SUBJECT: PERRY NUCLEAR POWER PLANT, UNIT 1 - STAFF ASSESSMENT OF INFORMATION PROVIDED PURSUANT TO TITLE 10 OF THE *CODE OF FEDERAL REGULATIONS* PART 50, SECTION 50.54(f), SEISMIC HAZARD REEVALUATIONS FOR RECOMMENDATION 2.1 OF THE NEAR-TERM TASK FORCE REVIEW OF INSIGHTS FROM THE FUKUSHIMA DAI-ICHI ACCIDENT (TAC NO. MF3729)

STAFF ASSESSMENT BY THE OFFICE OF NUCLEAR REACTOR REGULATION

RELATED TO SEISMIC HAZARD AND SCREENING REPORT

PERRY NUCLEAR POWER PLANT, UNIT 1

Figure 3.3-1: Plot of Staff's and Licensee's Base Case Shear-Wave Velocity Profiles for the Perry site

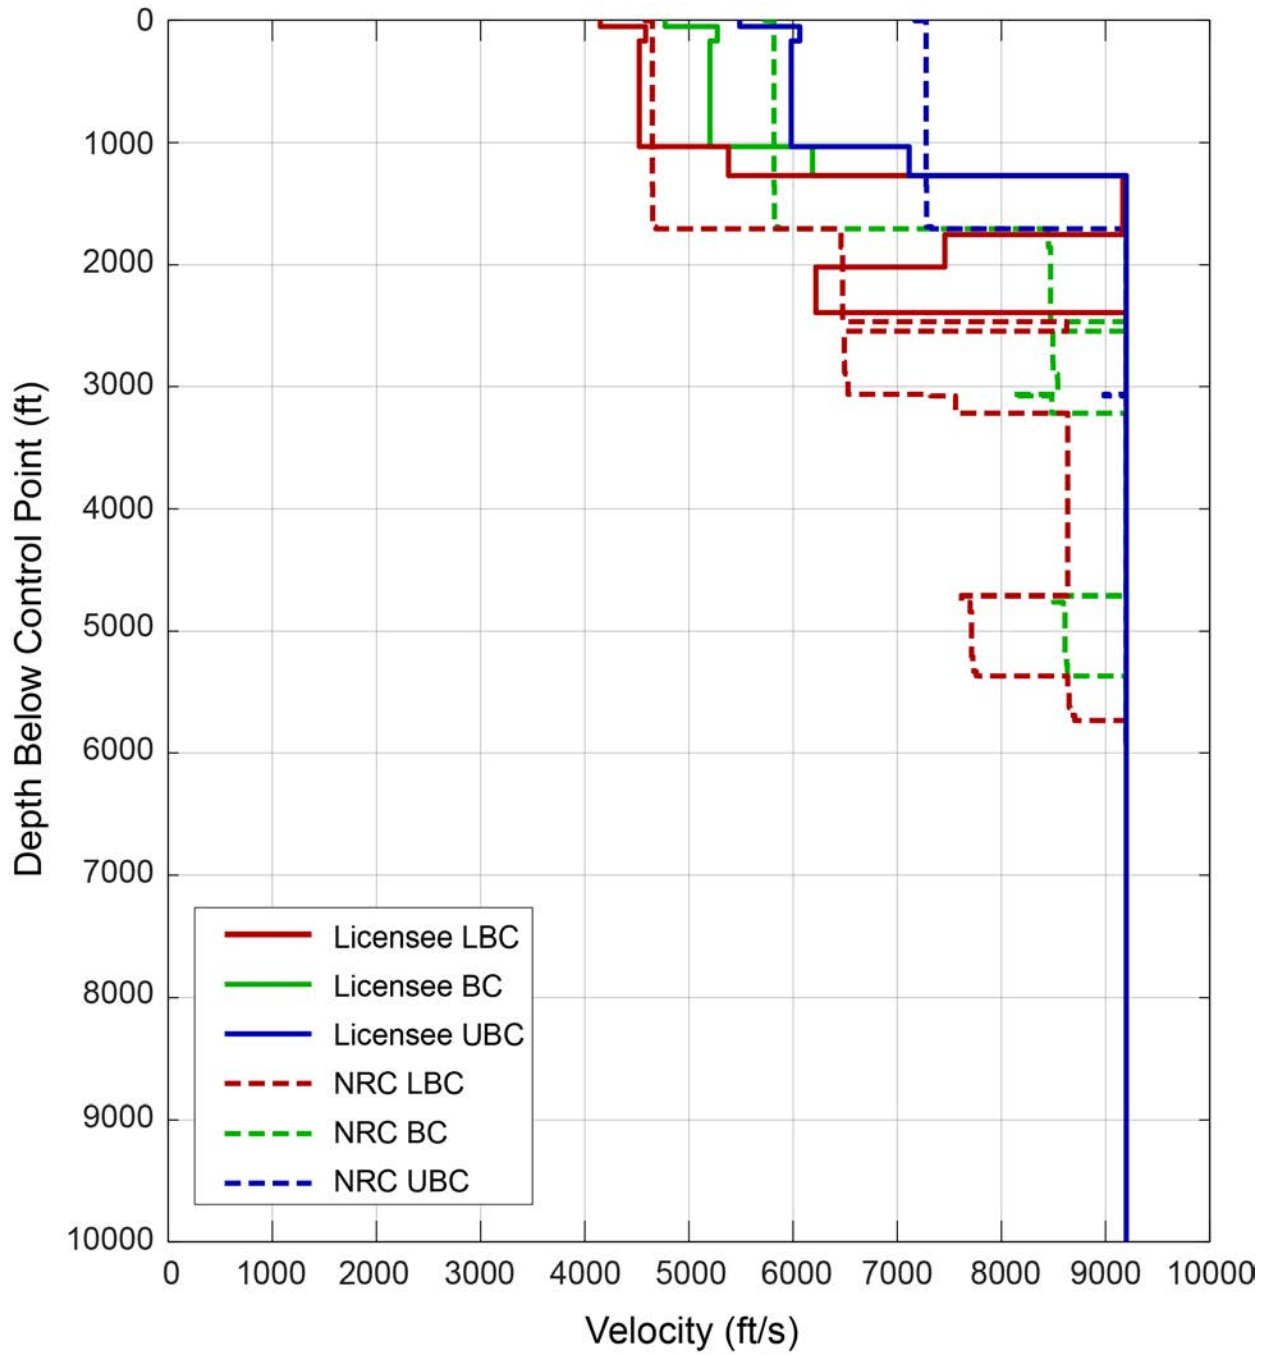
To characterize the subsurface geology, the licensee developed three site base case profiles (P1, P2, P3). The middle, or best estimate, profile was developed using measured shear-wave velocity from the site refraction surveys and cross-hole geophysical investigations. Upper and lower base case profiles were developed using a scale factor of 1.15. Consistent with the SPID, the licensee constrained the upper range base-case profile to not exceed a shear wave velocity of 9,200 ft/s [2,804 m/s]. Figure 3.3-1 of this assessment shows the licensee's three shear-wave velocity base case profiles.

Figure 3.3-2: Plot Comparing the NRC Staff's and the Licensee's Median Amplification Functions and Uncertainties for two input loading levels for the Perry site

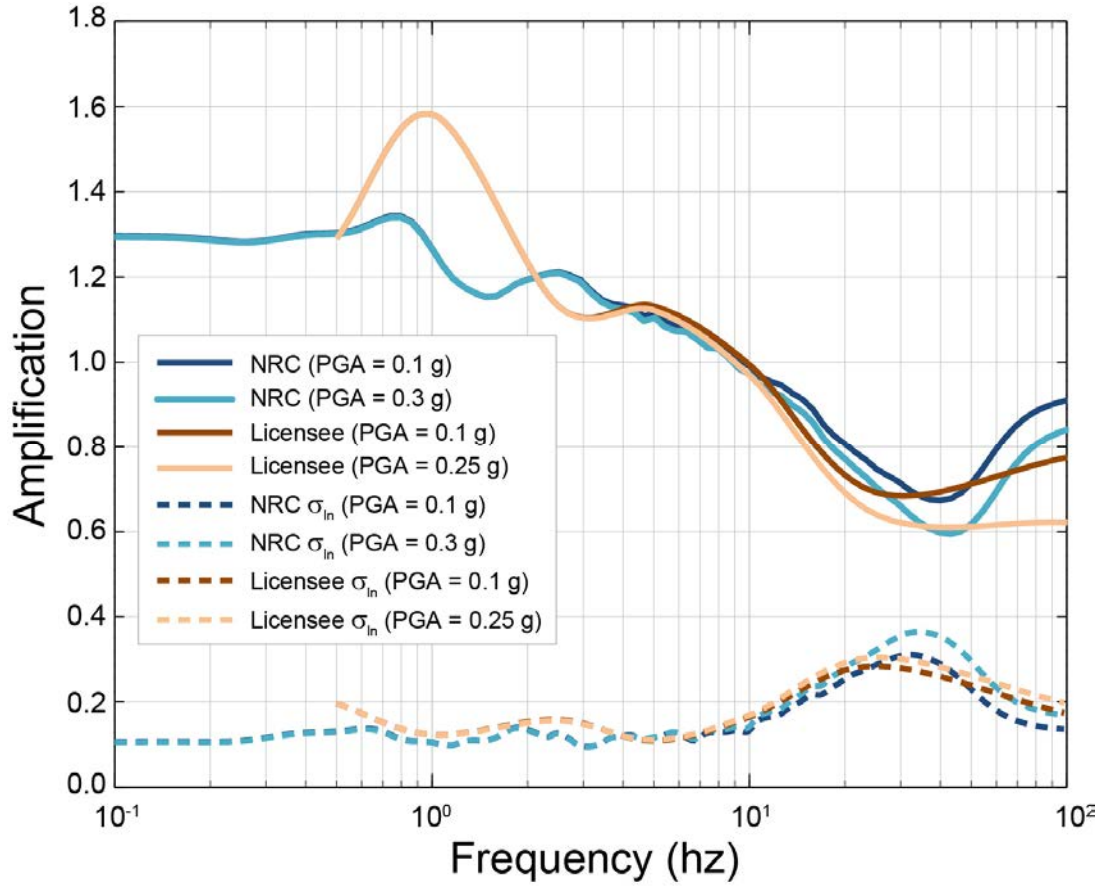
Figure 3.3-2 of this assessment shows a comparison of the NRC staff and the licensee median site amplification functions and uncertainties for 2 of the 11 input loading levels. As shown in this figure, the licensee's amplification functions are very similar to those of the NRC between 2 to 100 Hz, but slightly higher between 0.5 to 2 Hz. Overall, the licensee's approach to modeling the subsurface rock properties and the associated uncertainties result in similar site amplification factors with slight differences. Figure 3.3-3 of this assessment shows a comparison of the licensee and NRC control point hazard curves, which are also very similar.

In summary, the NRC staff concludes that the licensee's site response was conducted using present-day guidance and methodology, including the NRC-endorsed SPID. The NRC staff performed independent calculations which confirmed that the licensee's amplification factors and control point hazard curves adequately characterize the site response, including the uncertainty associated with the subsurface material properties, for the PNPP site.

Figure 3.4-1: Comparison of the NRC Staff's GMRS with Licensee's GMRS and the SSE for the Perry site

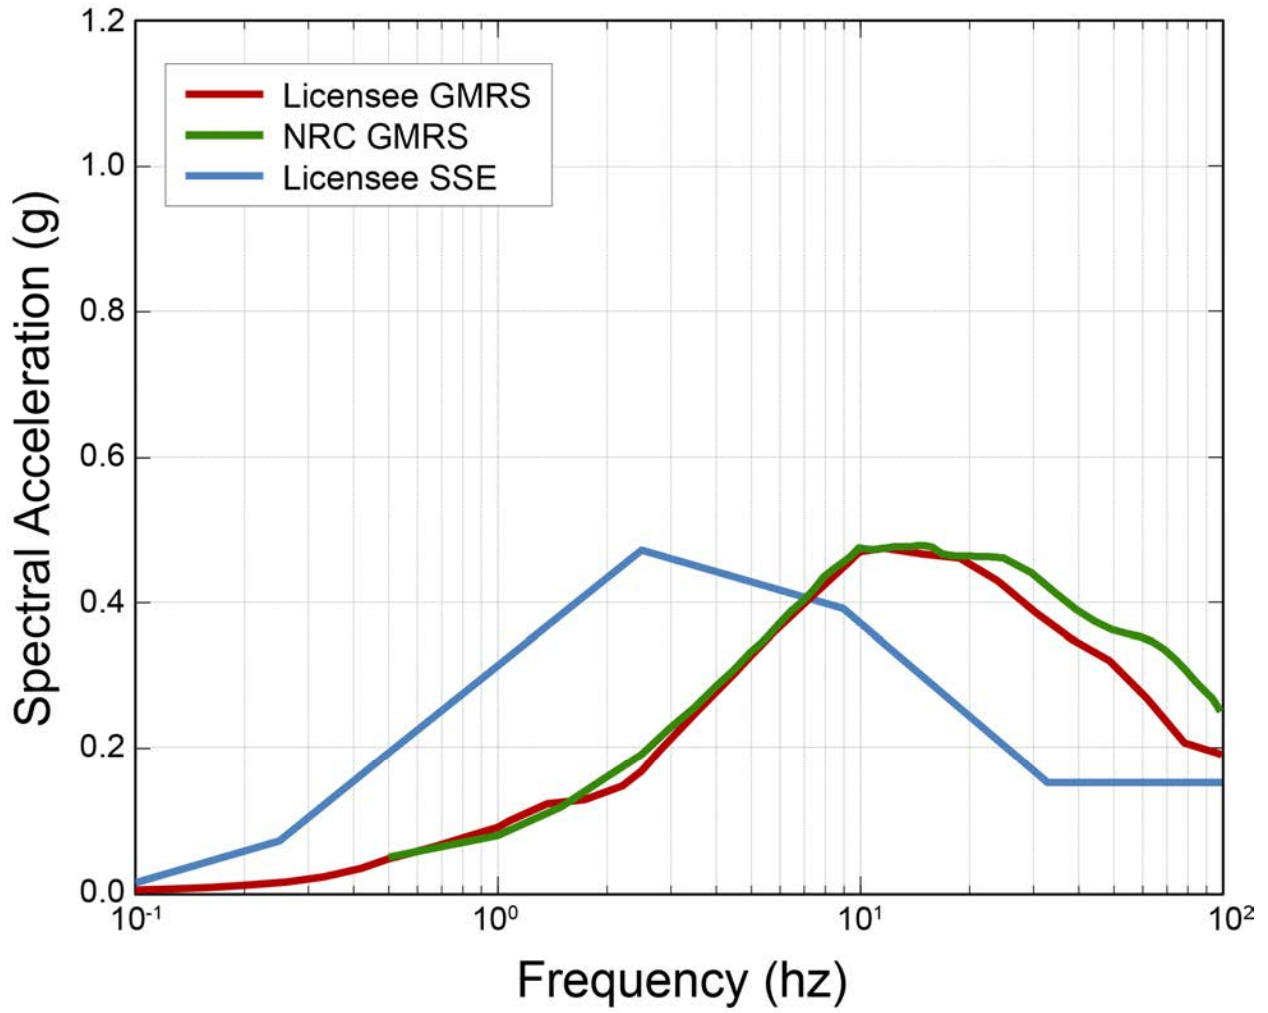
The NRC staff independently calculated the 10^{-4} and 10^{-5} UHRS using the results of its confirmatory PSHA and site response analyses, as described in Sections 3.2 and 3.3 of this staff assessment, respectively. Figure 3.4-1 of this assessment shows a comparison of the GMRS determined by the licensee to that determined by the NRC staff. As shown in Figure 3.4-1, the licensee's and NRC staff's GMRS shapes are generally similar. The licensee's GMRS is somewhat lower than the NRC staff's confirmatory analysis at frequencies between 20 and 100 Hz. As described above, in Section 3.3, the NRC staff concludes that these differences over this frequency range are primarily due to the differences in the site response analyses performed by the licensee and staff. The NRC staff concludes that these differences are acceptable for this application because the licensee followed the guidance provided in the SPID with respect to both the PSHA and site response analysis for the PNPP site.

The NRC staff confirms that the licensee used the present-day guidance and methodology outlined in RG 1.208 and the SPID to calculate the horizontal GMRS, as requested in the 50.54(f) letter. The NRC staff performed both a PSHA and site response confirmatory analysis and achieved results consistent with the licensee's horizontal GMRS. As such, the NRC staff concludes that the GMRS determined by the licensee adequately characterizes the reevaluated hazard for the PNPP site. Therefore, this GMRS is suitable for use in subsequent evaluations and confirmations, as needed, for the response to the 50.54(f) letter.
